Palo Verde Nuclear
Generating Station

**Subject: Palo Verde Nuclear Generating Station (PVNGS)
Unit 2
Docket No. STN 50-529
Request for Amendment to Technical Specification 3.5.5, Refueling
Water Tank (RWT), to Increase the RWT Minimum Water Level for
Unit 2 Under Exigent Circumstances**

Subject: **Request for Amendment to Technical Specification 3.5.5, Refueling Water Tank (RWT), to Increase the RWT Minimum Water Level for Unit 2 Under Exigent Circumstances**

FIGURE 3.5.5-1
Minimum Required RWT Volume

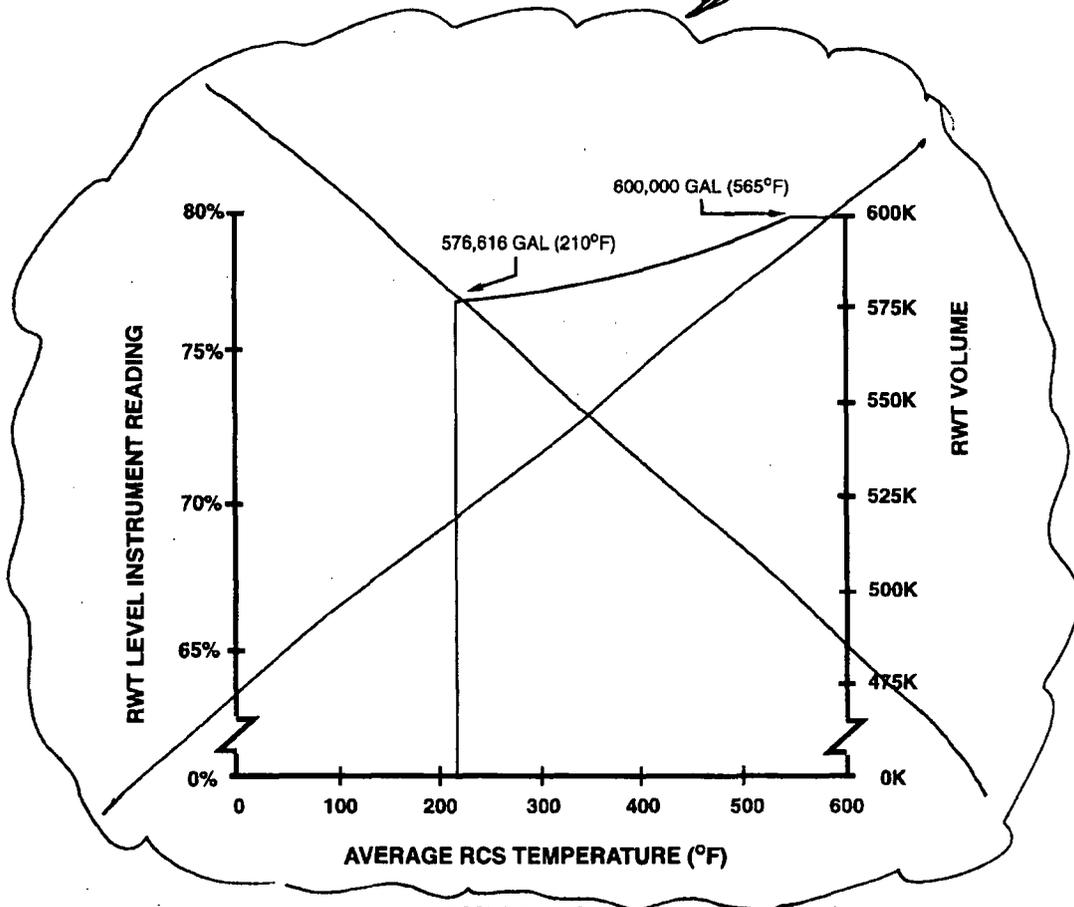
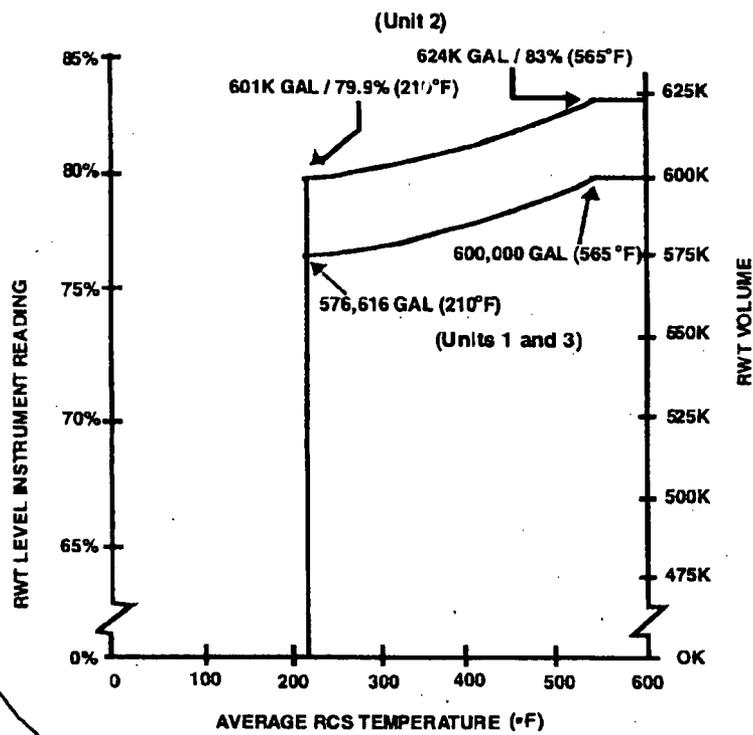
**Page:
3.5.5-3
Attached Figure**

Replace with Attached Figure

Replacement Figure For Figure 3.5.5-1

The proposed amendment would modify technical specification (TS) 3.5.5, Refueling Water Tank (RWT), to increase the minimum required RWT level indications and the corresponding borated water volumes in TS Figure 3.5.5-1 for Unit 2 by 3%. This change will ensure that there is adequate water volume available in the RWT to ensure that the engineered safety feature (ESF) pumps and the new containment recirculation sump strainers will meet their design functions during loss of coolant accidents (LOCAs).

The proposed amendment would revise TS 3.5.5 to raise the required minimum RWT level indications and the corresponding water volume values shown in Figure 3.5.5-1 by 3%. This change revises the minimum level indications and the corresponding water volumes used to determine operability of the RWT from 210 °F through 600 °F (i.e., to ensure that there is adequate volume available for the design functions of the RWT). This change will ensure that there is adequate water volume in the containment to meet the functional requirements of the ESF pumps and the containment sump strainers for applicable design basis accidents and break scenarios.

FIGURE 3.5.5-1
Minimum Required RWT Volume

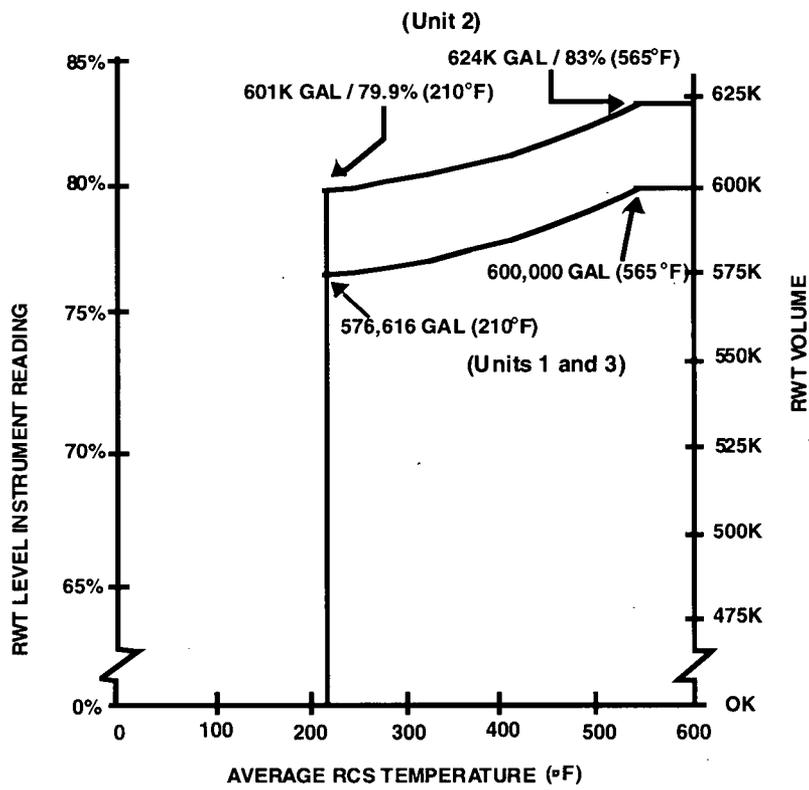
Page:
3.5.5-3
